|                                                                                                         | Title:               | I.D. # 2021\                       | Date:     | Date:       | Revision: REVISE THE SIZE AND SHAPE OF THE FLAT-WINDOW DIVIDER TO A FORMED                                  | By: R. F. P.     |
|                                                                                                         | SPLIT-WINDOW DIVIDER | HE\CAB\WN\<br>KG_SPLIT-WIN_DIVIDER | 12/12/19  | 12/16/19    | PART, THE LENGHT WAS REDUCED FROM 32 3/4" TO 32 5/8", ADDED PG 2. (PCR #211130)                             | Date:BLG 7/8/20  |

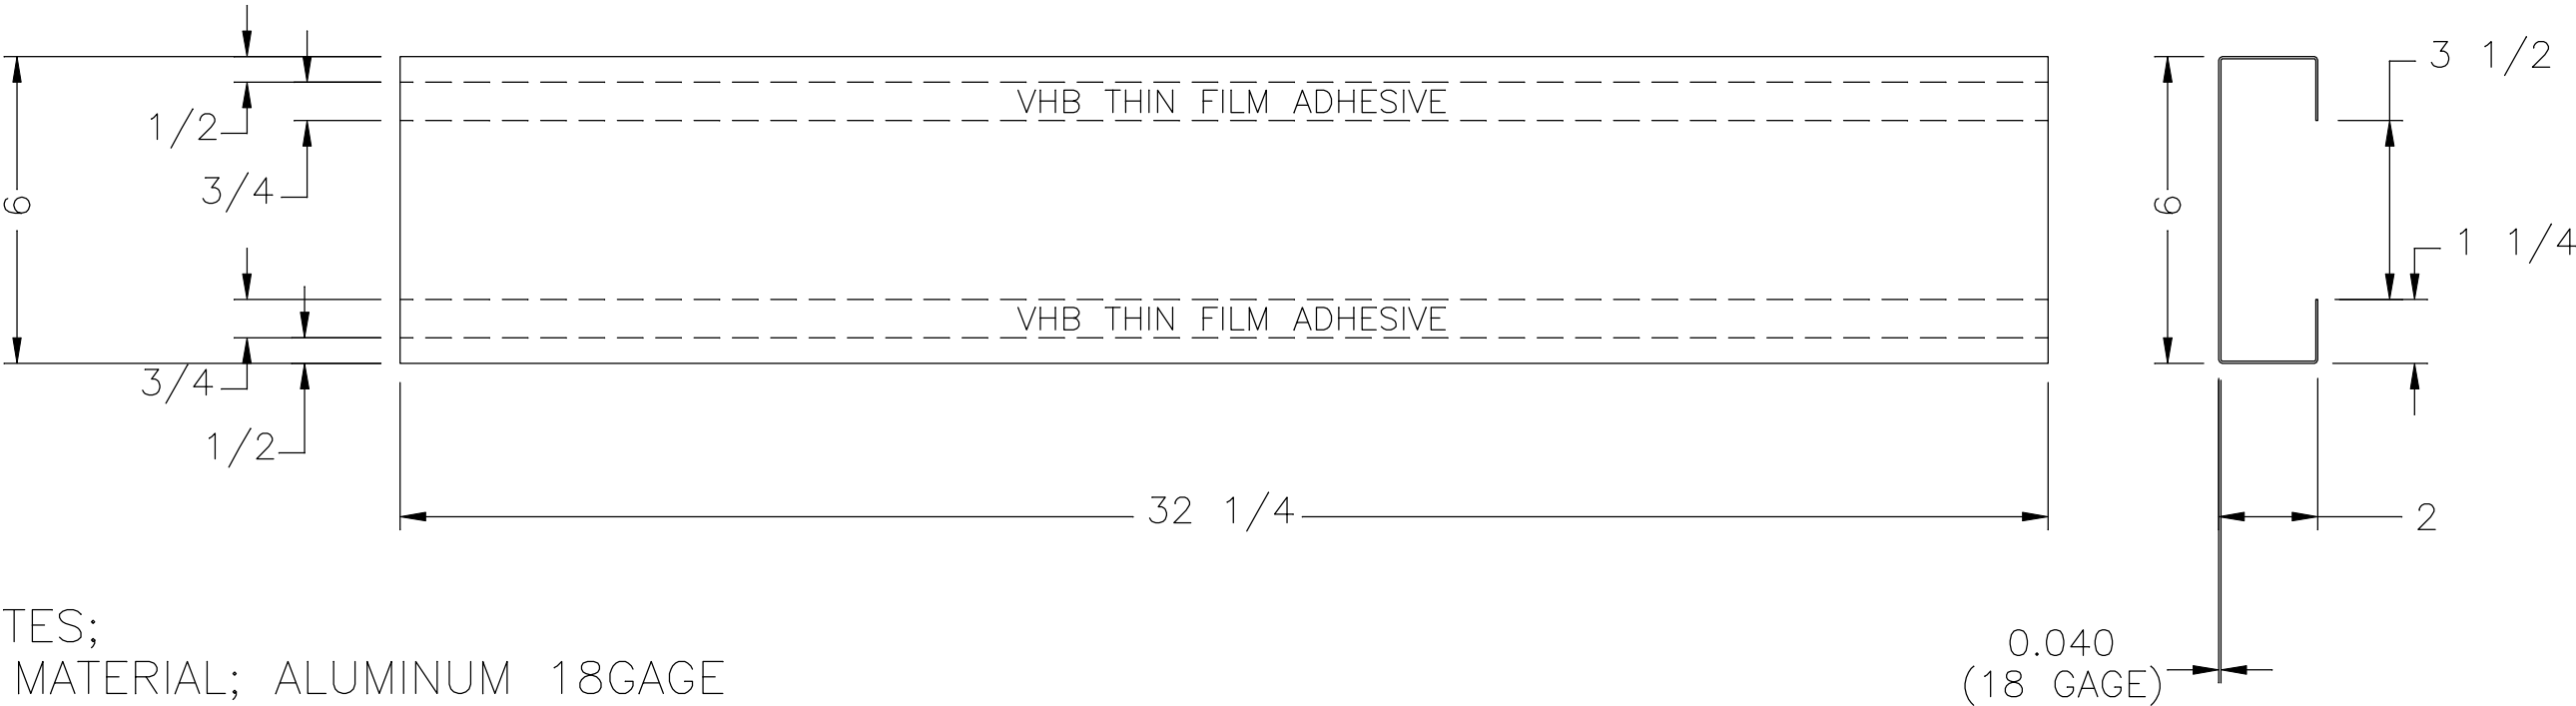
| <b>NEWMAR CORP</b><br>P.O. Box 30,<br>Nappanee, IN. 46550<br><br>UNITS: INCHES<br>TITLE BLOCK: 1-4FULTB | Model:               | Sheet                              | Drawn by: | Checked by: | Revision: REDUCE LENGTH FROM 32 5/8" TO 32 1/4", PG #1 DELETE HOLE FOR POWDERCOAT, REMOVE                   | By: R. F. P.     |
|                                                                                                         | KGDB (SEE INDEX)     | 1 OF 2                             | K. B.     | B. L. G.    | TAPE REFERENCE, ADD NOTE #6, PG#2 REMOVE REFERENCE TO VHB THIN FILM ADHESIVE, (PCR #211198) (2021 ECO# 437) | Date:BLG 7/24/20 |
